Boston Edison

Pilgrim Nuclear Power Station
Rocky Hill Road
Plymouth, Massachusetts 02360-5599

Response to Request for Additional Information Dated July 14, 1998 For Resolution of
Generic Letter (GL) 96-06 Issues at Pilgrim Nuclear Power Station, Unit 1 (TAC No.
M96851)

Attachment to BECo Letter 2.98.123
Response to GL96-06 RAI

SIMPLIFIED RBCCW SYSTEM DRAWING

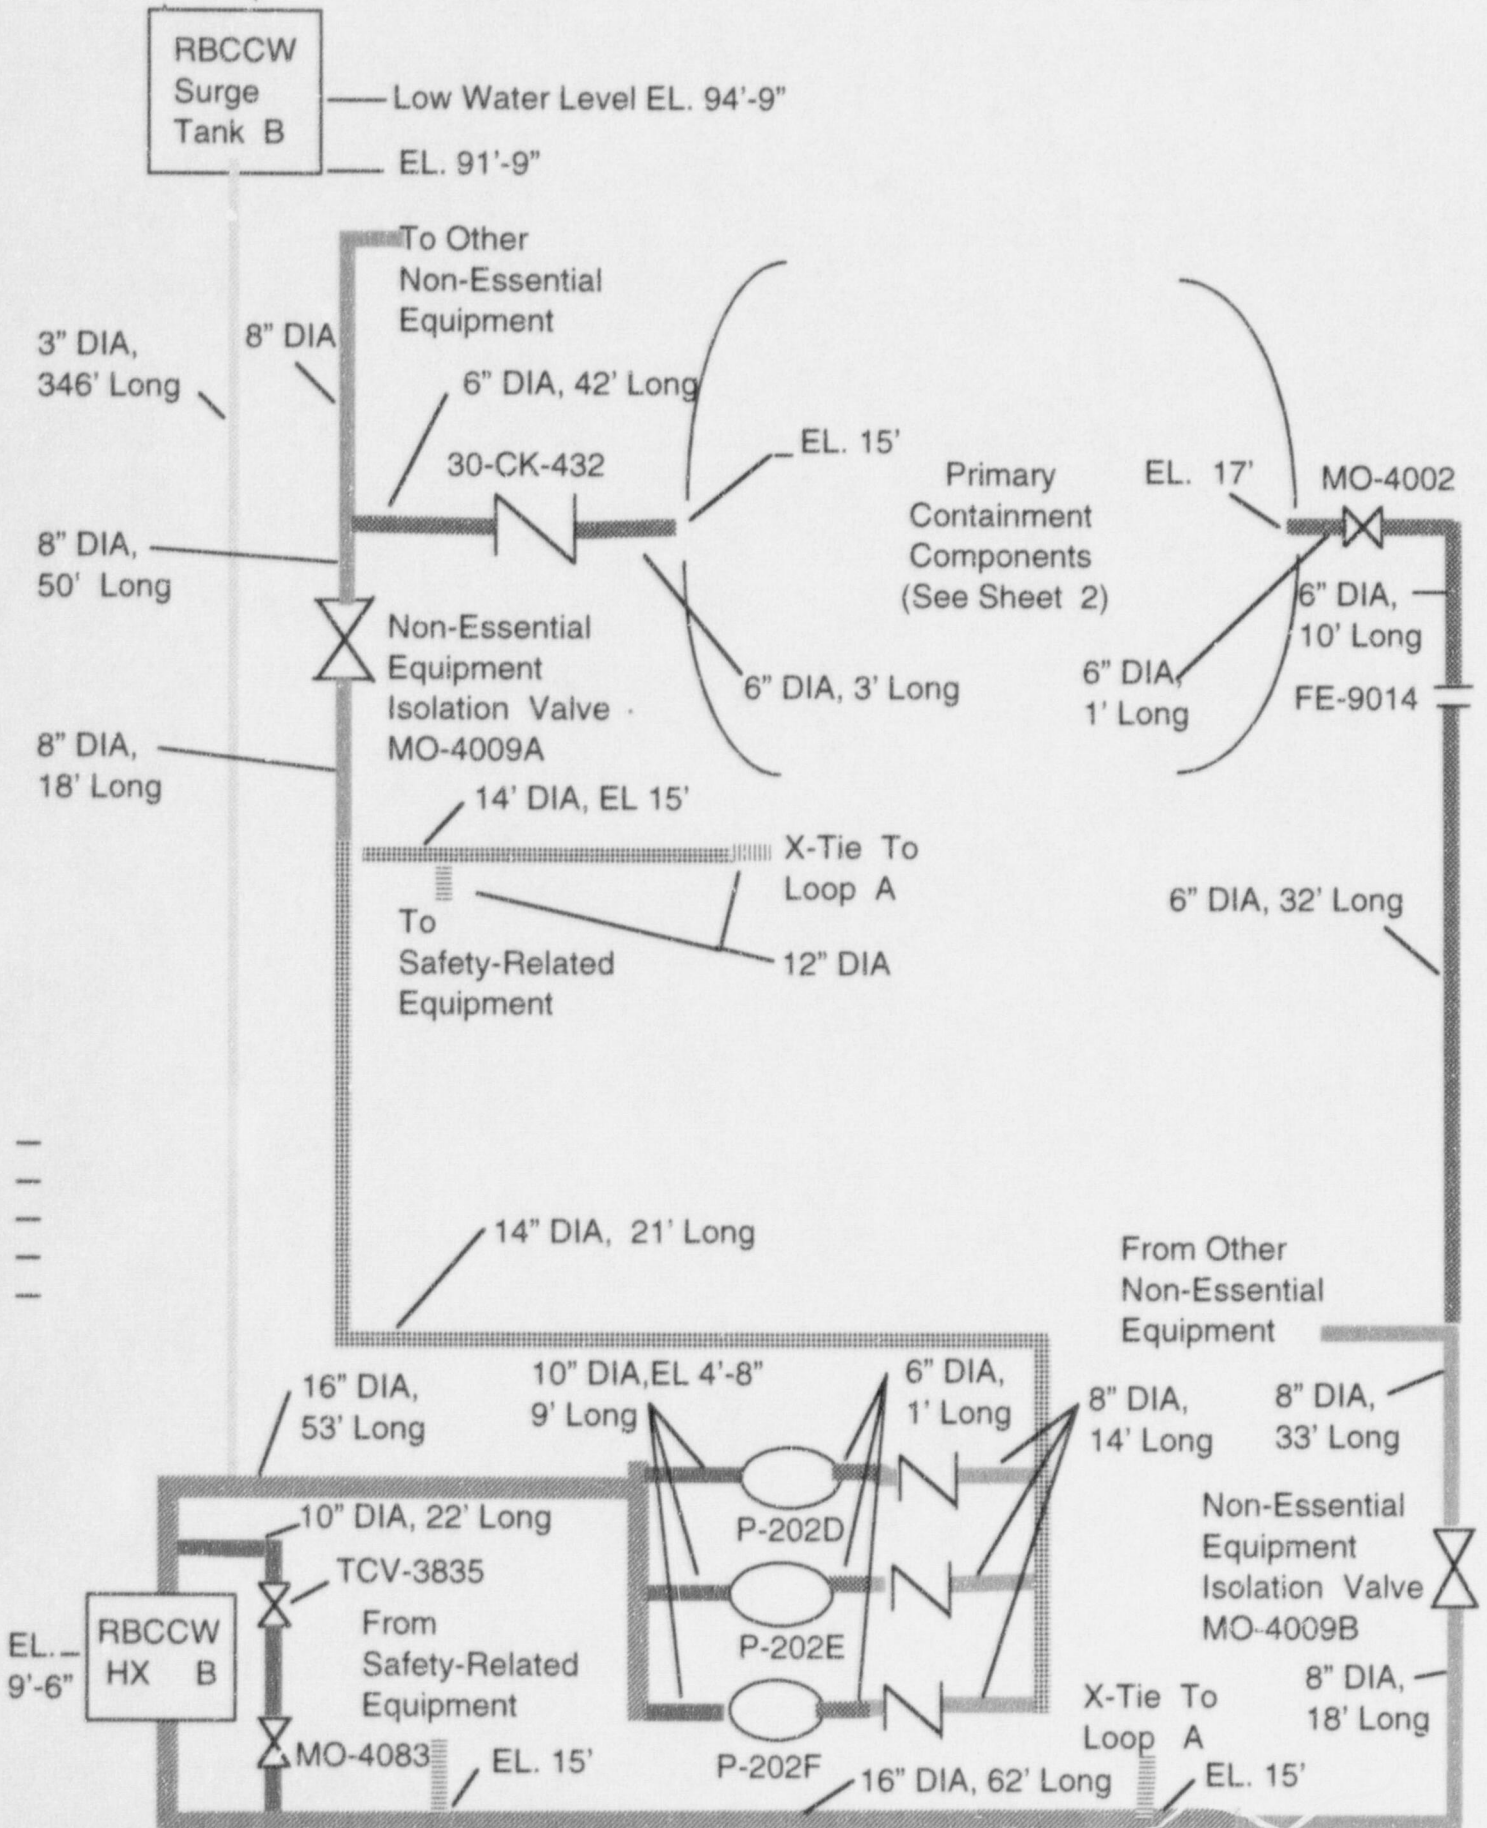
Provide a simplified diagram of the affected systems, showing major components, active components, relative elevations, lengths of piping runs, and the location of any orifices and flow restrictions.

See the attached figure.
